# NATIONAL WATER COMMISSION

## CONSUMER WATER METER INSTALLATION

CP-17/2018

Addendum N° 1

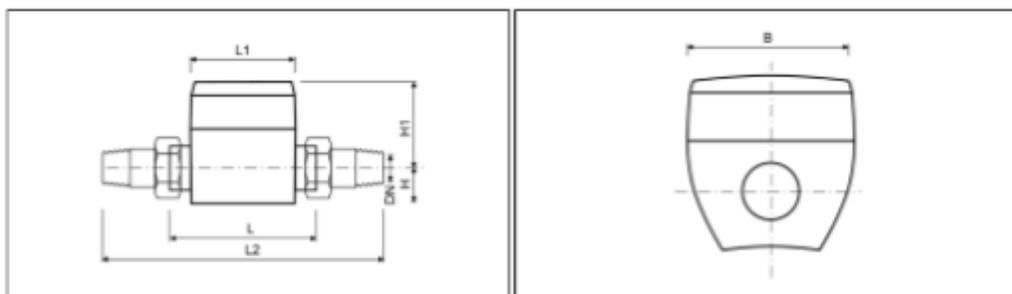
With reference to Section VI Specifications & Performance Requirements, could you please provide the following specifications of the Diehl Hydrus ultrasonic water meters to be provided by NWC: meter size, meter length, thread connection type and dimension, quantity of each meter size?

See table overleaf.
